Dear Reviewer,

We thank you for your willingness to review our manuscript and for your constructive and thorough comments on the manuscript. Please find our responses to your comments in blue below.

Elin Andrée, Jian Su, Morten Andreas Dahl Larsen, Martin Drews, Martin Stendel and Kristine Skovgaard Madsen

Figure 1: Map of the study area: A zoom in to the Danish Straits (panel (a)) and the Baltic Sea (panel (b)). The panels mark locations mentioned in the text. Red dots indicate locations that the analysis focusses on.

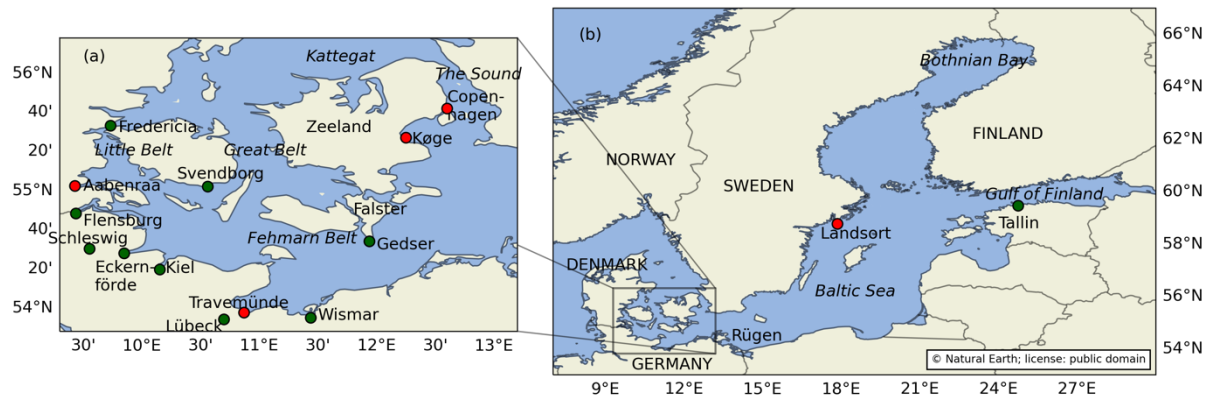
Line 8: as far as I understood, the 36 cm was not seen, it was rather simulated. Also, I would replace “Danish capital region” with “Copenhagen region (Denmark)”. Please note that not everybody is familiar with Baltic Sea’s geography, so all the references to cities and places should be supported by figures and/or more detailed descriptions (see also below).

From line 108 onward: all the cities mentioned should be shown in a figure so that the reader can spot where the different locations are, otherwise, it is very annoying to look them up on e.g., google earth every time

Figure 1: please extend the colorbar so that it includes also the left-side panels. Also, please change the marker color of Landsort as it is not easy to see it (green perhaps?). The Figure should be included after it is first referred to, i.e., in Section 2.2.1

Page 10, section 3: Travemunde and the Gulf of Bothnia are mentioned in the text but not shown in any Figure (note that Figure 4 is introduced at a later time)

Line 380 onward: again, the locations are not shown in figures

We added Figure 1 to show a map of the study area.

Agreed - we added them in new Figure 1.

Agreed - revised.

We have now indicated these locations in the new Figure 1.

Noted. We added them in the new Figure 1.
